# Access Compliance Report

## Public Rights-of-Way

### (Curb Ramps)

Intersection ID: 17030	Main Street: JUDITH_CT	Cross Street: WATER_OAK_RD	Location: SW
ADA ID: 2B8C9DC61EDE	Ramp Type: Perp	Initial Pass/Fail: Fail	Overall Compliance: No
Severity Score: 13.75			
Codes/Mitigation Info/Possible Solution		Field Measurements/Component Compliance

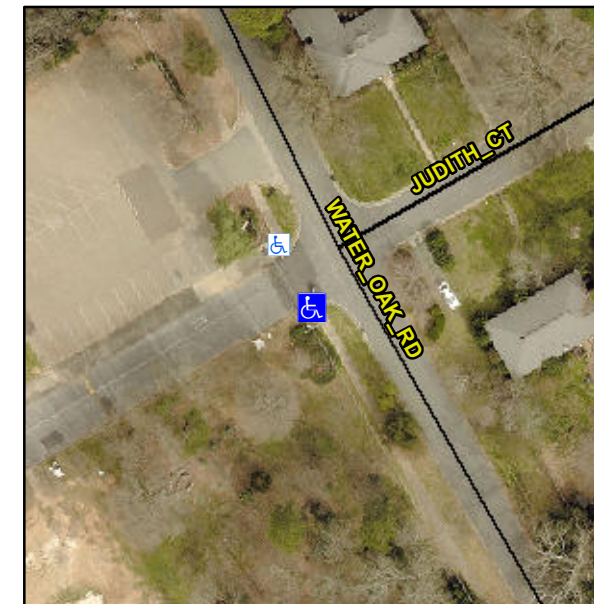
**R304.2.2, R304.5.3**

Compliance	Description	Data	Compliance	Description	Data
N/A	Ramp Length (in)	28.0	No	Ramp Slope (%)	10.1
Yes	Ramp Width (in)	53.0	No	Ramp XSlope (%)	3.4
N/A	Flare Type LT	N/A	N/A	Flare Type RT	N/A
N/A	Flare Slope LT (%)	N/A	N/A	Flare Slope RT (%)	N/A
N/A	Flare Traversable LT?	N/A	N/A	Flare Traversable RT?	N/A
N/A	Landing Length (in)	N/A	N/A	DWS Provided?	N/A
N/A	Landing Width (in)	N/A	N/A	DWS Contrast?	N/A
N/A	Landing Slope (%)	N/A	N/A	DWS Length (in)	N/A
N/A	Landing X Slope (%)	N/A	N/A	DWS Full Width?	N/A
N/A	Landing Curb? (Y/N)	N/A	N/A	DWS Offset (in)	N/A
N/A	Shared Landing?	N/A			
N/A	Gutter Ponding?	N/A	N/A	Gutter Slope (%)	N/A
N/A	Gutter Lip Ht (in)	0.5	N/A	Gutter X Slope (%)	N/A
N/A	Painted X Walk1?	No	N/A	Painted X Walk2?	N/A
	X Walk 1 Direction	To NW		X Walk 2 Direction	N/A
N/A	X Walk 1 Width (in)	N/A	N/A	X Walk 2 Width (in)	N/A
	X Walk 1 Slope (%)	5.5		X Walk 2 Slope (%)	N/A
	X Walk 1 X Slope (%)	1.6		X Walk 2 X Slope (%)	N/A

**Remove & Replace Entire Ramp.**
